Architectural Commission Report

Meeting Date: Wednesday, March 20, 2013

Subject: **CHASE BANK**
9797 Wilshire Boulevard
Request for approval of a façade modification and a sign accommodation to allow multiple business identification signs.
(PL1303395)

N4 CUSTOM OCTAGON 14.6 SQ FT

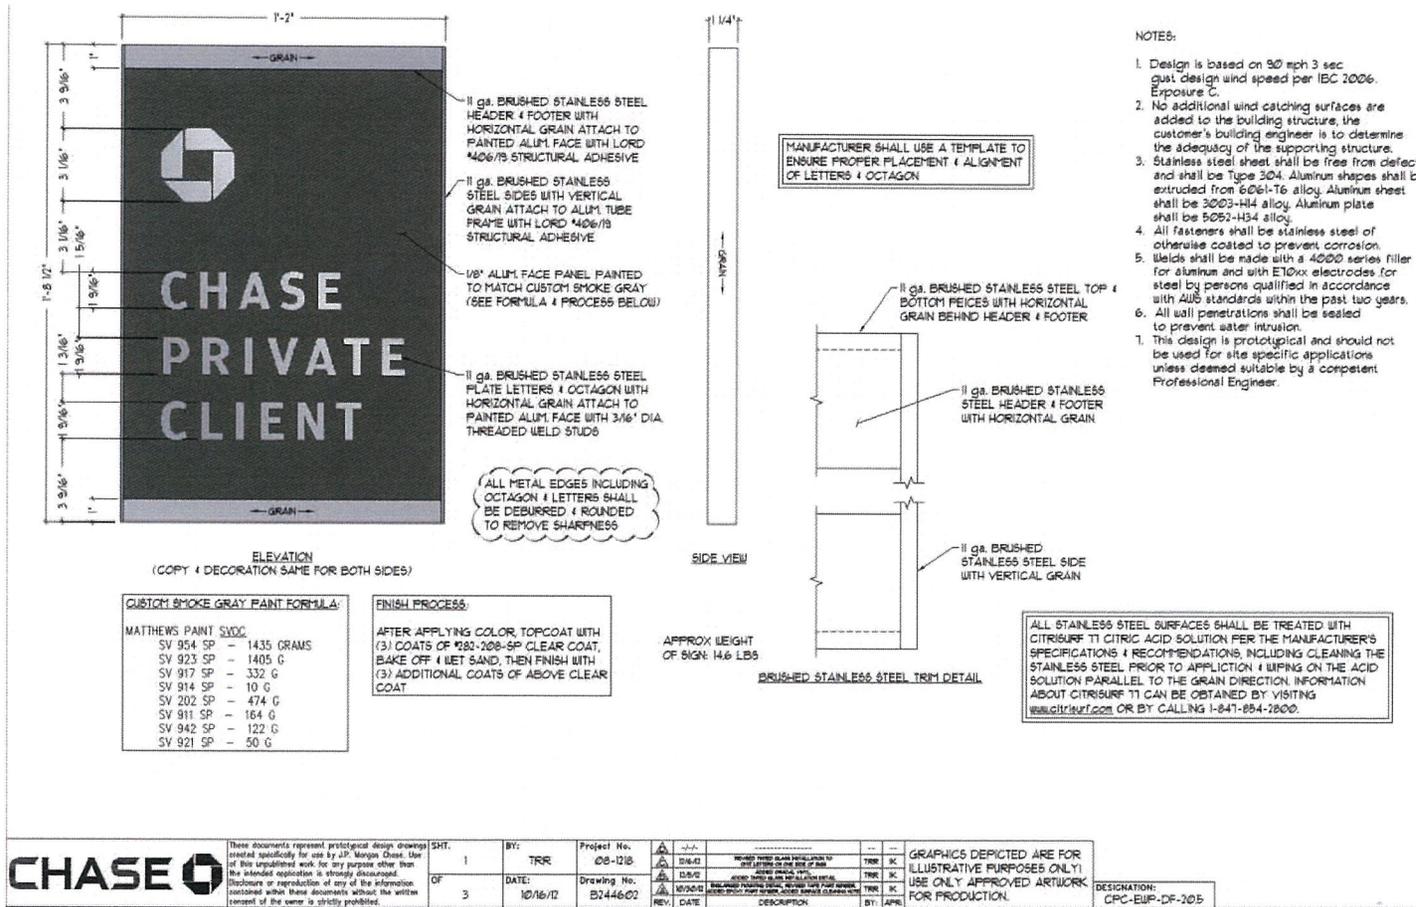
The total area proposed for business identification signage is 25.68 SF. As such, the business identification signage currently complies with the standards set forth in the BHMC. However, as part of the pre-review for this project, concern was expressed regarding the illuminated sign located in the window of the façade of the intersection elevation. As such, a condition has been added to the resolution that would remove the hanging illuminated sign and replace it with a non-illuminated sign, of

Interior items for review under this ARB are items considered interior signage with in the proposed vestibule such as; a proposed hanging illuminated octagon, illuminated low partitions at (2) "self service bankers" and digital media monitors behind the "self service bankers".

“The illuminated Chase Bank octagonal logo sign, attached from the ceiling on the interior of the building, shall be removed and replaced with a non-illuminated sign attached to a pedestal-type fixture. The new sign may be configured in a color and size that is consistent with that proposed for the sign attached from the ceiling. The new sign shall not be located any nearer to the storefront than it would have been if it were attached from the ceiling.”

9. The illuminated Chase Bank octagonal logo sign, attached from the ceiling on the interior of the building, shall be removed and replaced with a non-illuminated sign attached to a pedestal-type fixture. The new sign may be configured in a color and size that is consistent with that proposed for the sign attached from the ceiling. The new sign shall not be located any nearer to the storefront than it would have been if it were attached from the ceiling.
